UNITED STATES PATENT AND TRADEMARK OFFICE

APPLICATION NO.	FILING DATE	FIRST NAMED INVENTOR	ATTORNEY DOCKET NO.	CONFIRMATION NO.
10/646,611	08/22/2003	Guy Simon Dawson	37261P087	9810

Office Action Summary	Application No. 10/646,611	Applicant(s) DAWSON, GUY SIMON	
	Examiner Vinh T Luong	Art Unit 3682

ATTACHMENT

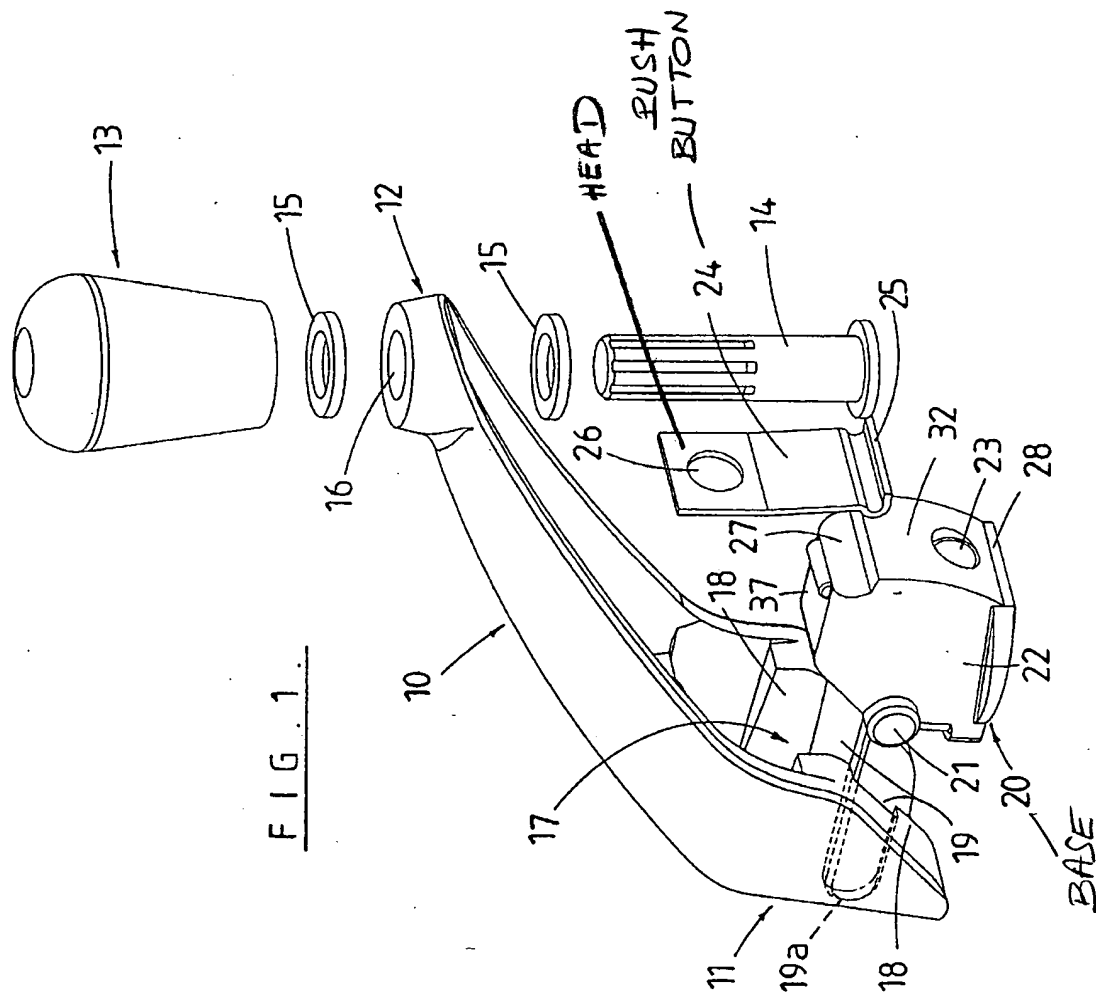
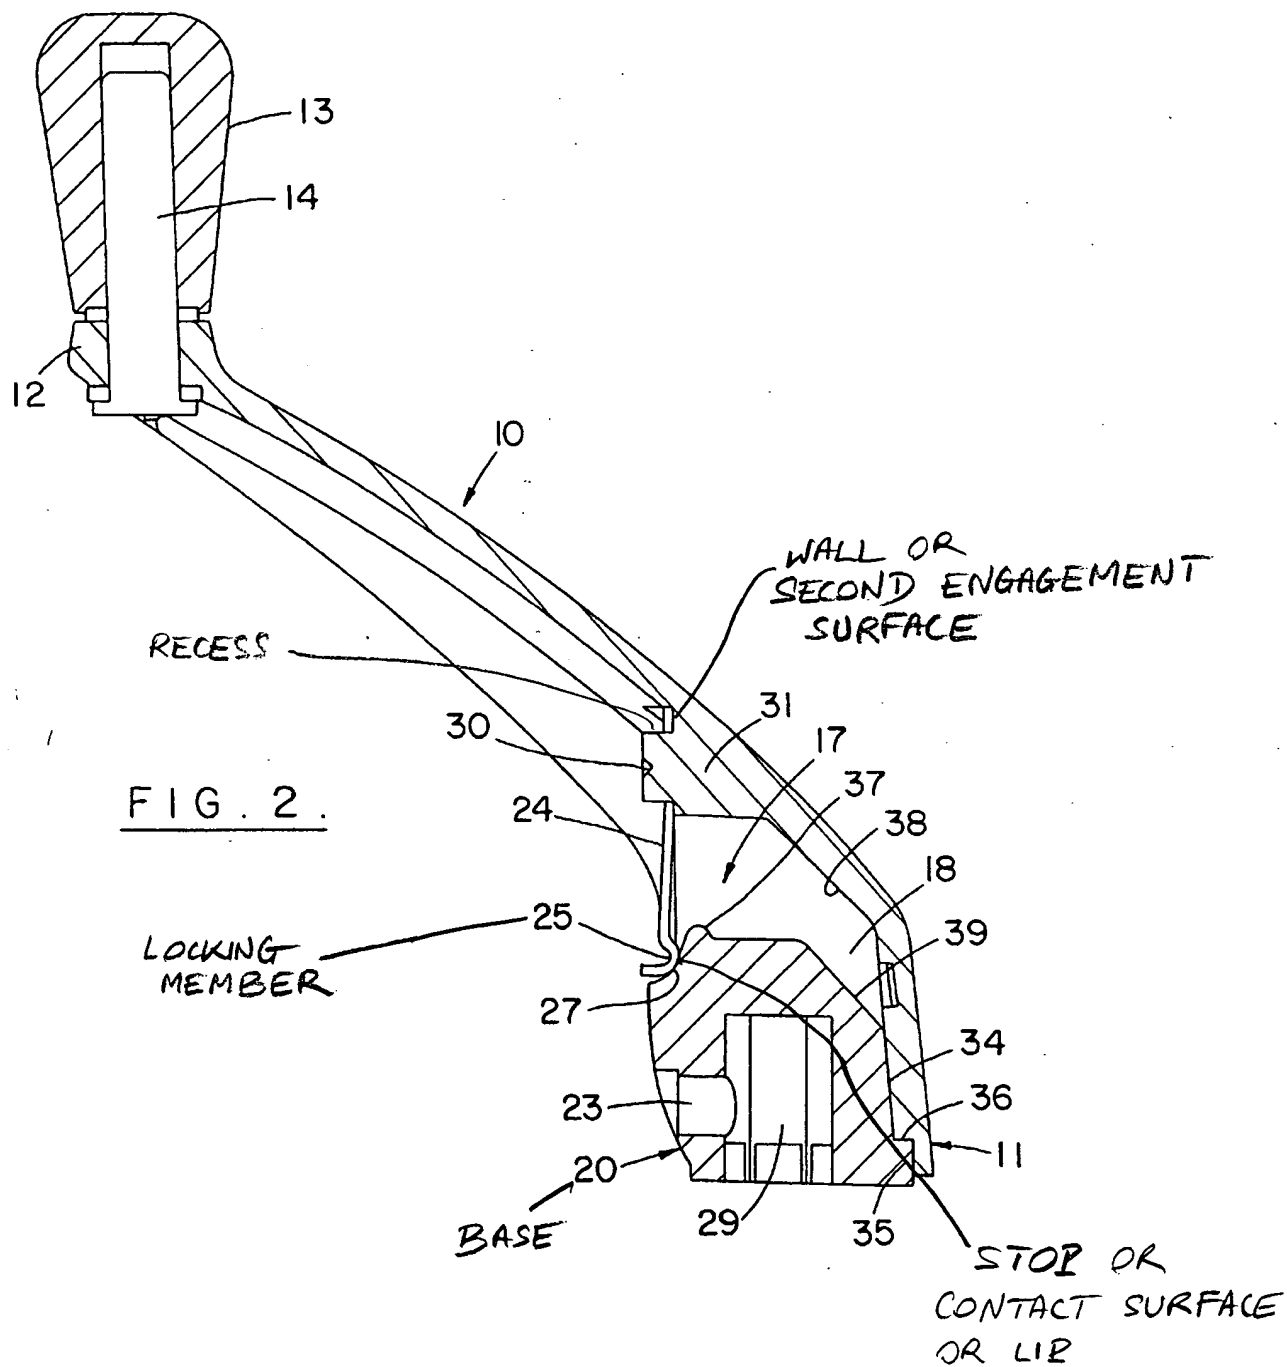
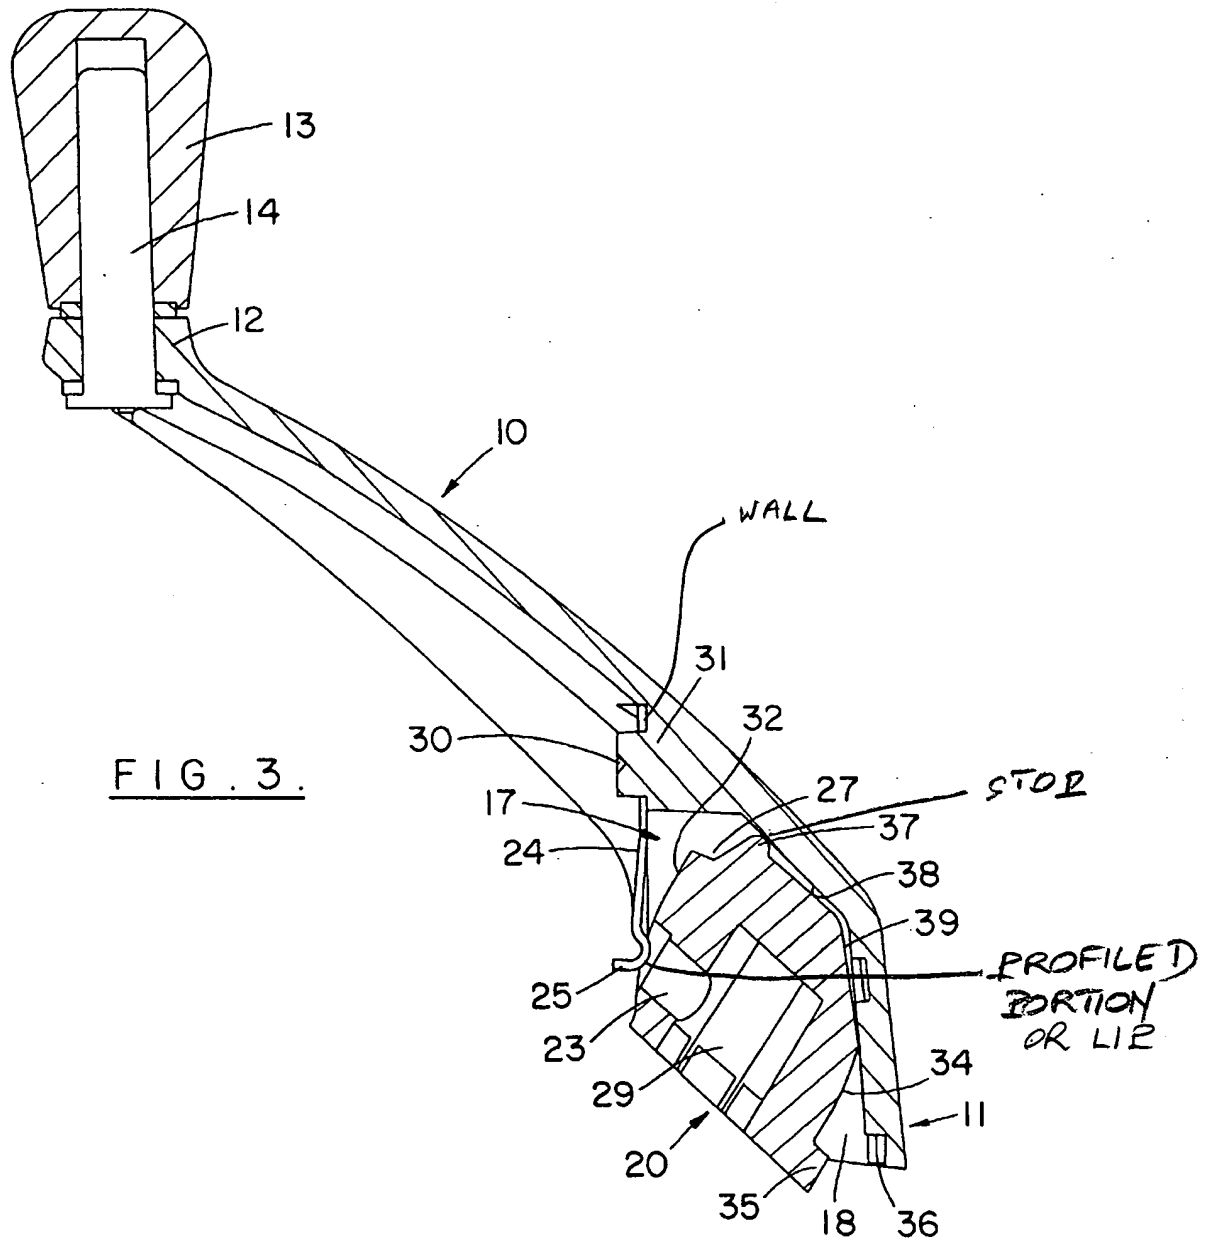
Regarding claim 2, the push button 24 includes a head (see Attachment, Fig. 1) which is slidably located in a recess (Fig. 2, Att.) the handle member 10.

Regarding claim 3, the peripheral shape of the recess (Fig. 2, Att.) substantially corresponds to the peripheral shape of the button 24.

Regarding claim 7, see a stop 25 (Fig. 2, Att.) to prevent movement of the locking member 25 under action of the biasing mechanism 24 from moving beyond the locking position (Fig. 2). *Ibid.*, col. 3, lines 7-25. Alternatively, see a stop 37 (Fig. 3) to prevent movement of the locking member 25 under action of the biasing mechanism 24 from moving beyond the locking position.

Regarding claim 10, the locking member 25 includes a profiled portion 25 (Att.) which provides a clearance (at 23 in Fig. 3) between the locking portion 25 and the pivot base 20 when the locking member 25 is in the release position (Fig. 3).

Regarding claim 11, the profiled portion 25 includes a contact surface (Att.) which contacts a profiled surface 27, 28 of the pivot base 20 during movement of the handle between the first and second positions (Figs. 2 and 3).

Regarding claim 13, the recess (Fig. 2, Att.) includes a contact surface 30 which is contacted by the head (Fig. 1, Att.) when the locking member 25 is in the release position.

Regarding claim 18, the lip 25 projects from the locking portion 25. The engagement surface 30 is formed by a wall (Att., Figs. 2 and 3) in the handle member 10. The wall (Att.) further forms a second engagement surface (Att.). The locking portion 25 of the locking member 25 is located between second engagement surface (Att.) and the pivot base 20 to create the blocking action.
